Project Proposed new access to Horrocksford Hall

Title Scheme drawing

Drq No
406/1/1
Rev **A**

Proposed route of track Scale 1:1000

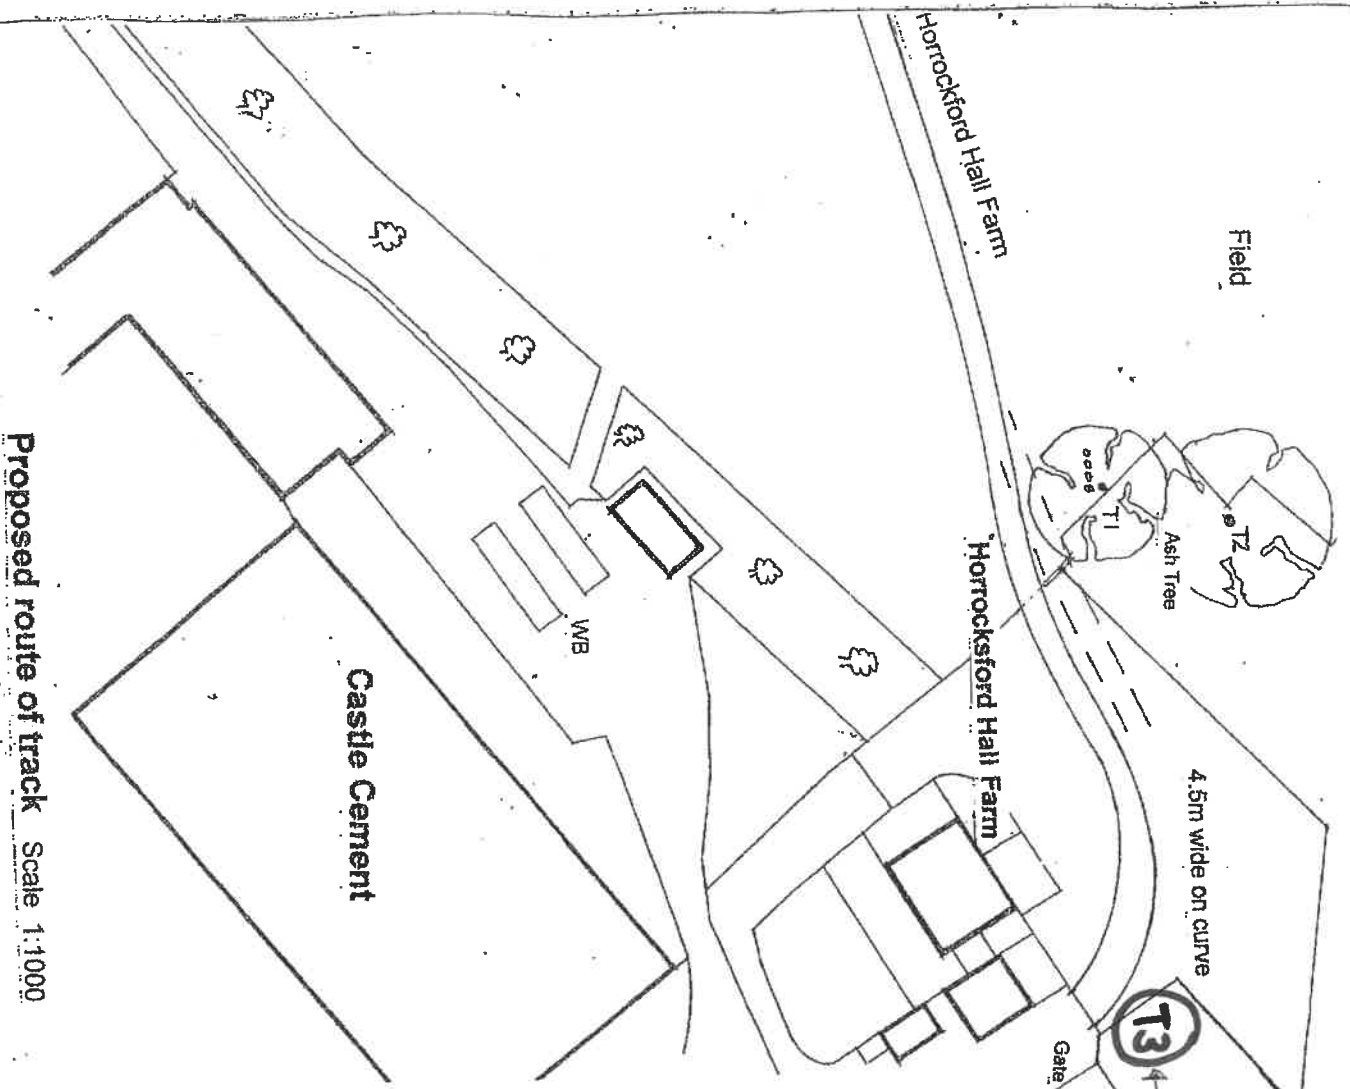
Root zone 12m
Existing 2.8m gateway to be built up in dry stone
and new access created SE twelve metres from T1.

- A. Alternative to gate using a cattle grid
1. Hedge maximum height of one metre.
2. Ash tree to be skirted around to give root clearance.
3. Track moved over at the tree
- C. 4. Extra details added
5. Concrete channel and kerbs added
